REMARKS

The Office Action dated August 12, 2005, has been received and carefully noted. The above amendments to the specification and claims, and the following remarks, are submitted as a full and complete response thereto.

FIG.2

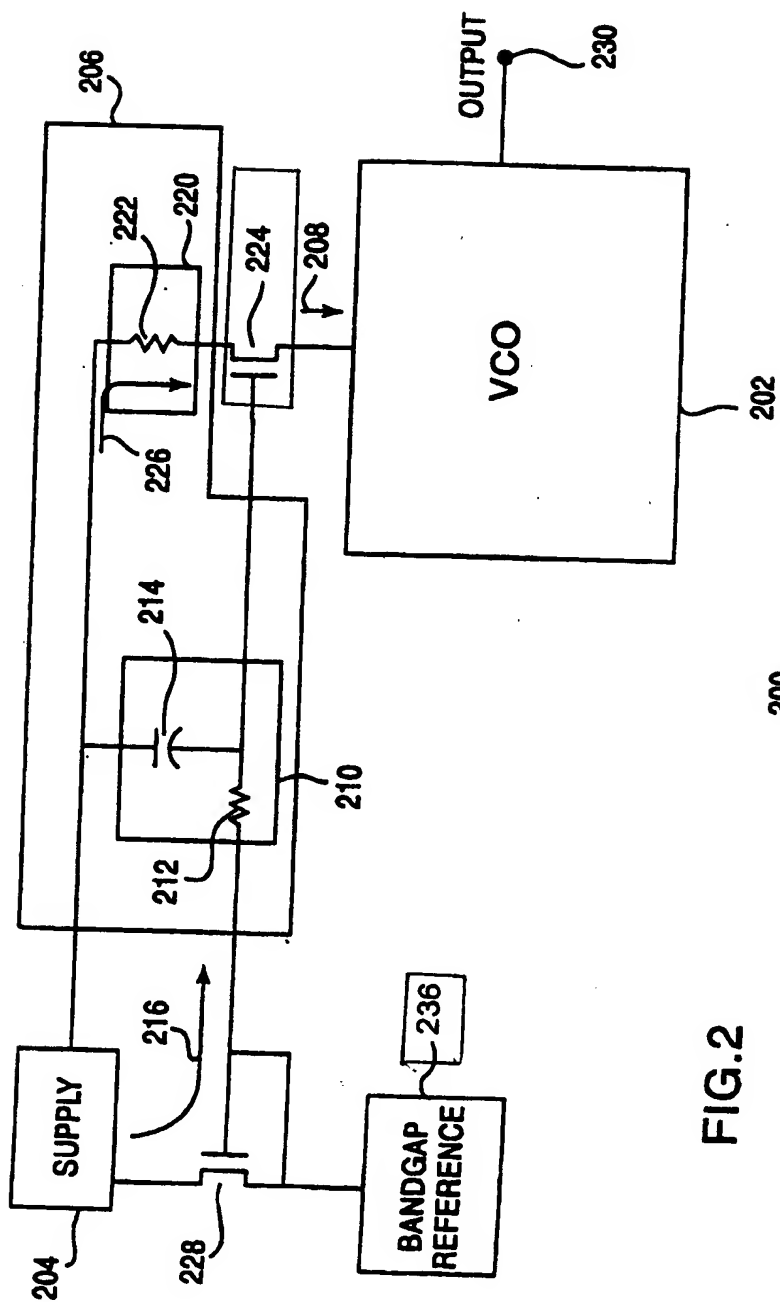
The Office Action objects to Figure 2, because reference numeral 226 was used for both the bandgap reference circuit and the supply current, and because the symbol for

current source 224 is not recognizable. Applicant has renumbered the bandgap reference circuit as 236 in Figure 2, and in paragraphs 0028, 0031, 0034, and 0045 of the specification. A courtesy copy of the revised figure circling the changed parts has been included.

Please replace Figure 2 as filed with Replacement Figure 2, attached.
